# Technical Service Information

## **FORD E4OD PREMATURE OVERDRIVE CLUTCH FAILURE (INCREASED CAPACITY)**

Figure 1

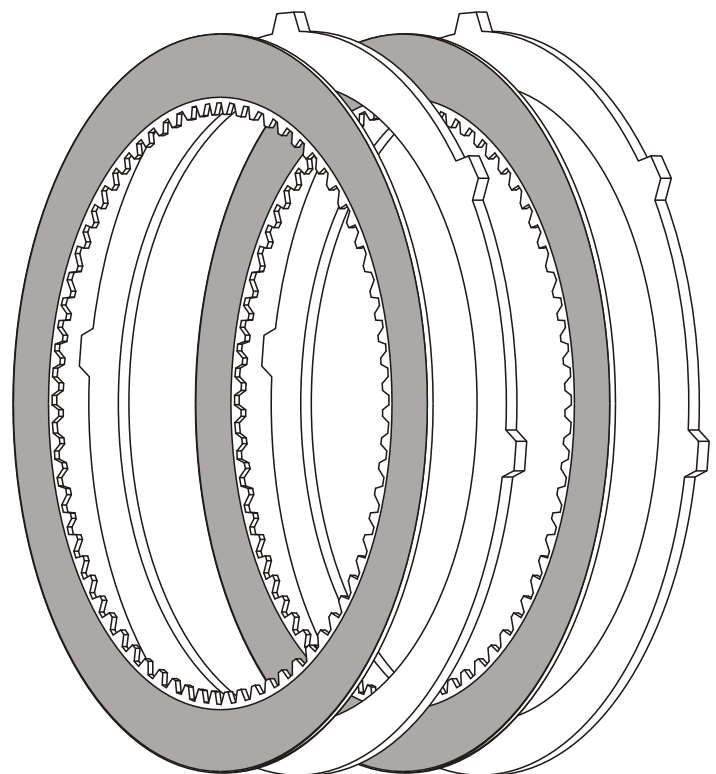
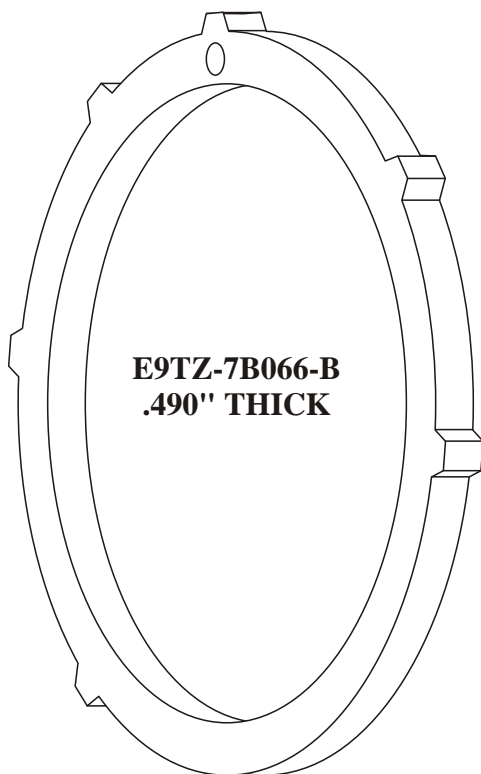
**COMPLAINT:** Some vehicles equipped with the E4OD transmission may exhibit premature failure of the overdrive clutches, especially heavier loaded vehicles.

**CAUSE:** The cause may be, not enough clutch capacity for the overdrive clutch.

**CORRECTION:** Install 3 clutches in the overdrive clutch pack by purchasing a thinner, .320" thick backing plate, to replace the previous .490" thick backing plate. The 3 clutch backing plate is available under OEM part number F3TZ-7B066-A. Refer to Figure 1 for both 2 clutch and 3 clutch stack-ups.

Overdrive Clutch Backing Plate (3 Clutch) .....	F3TZ-7B066-A
Overdrive Clutch Backing Plate (2 Clutch) .....	E9TZ-7B066-B
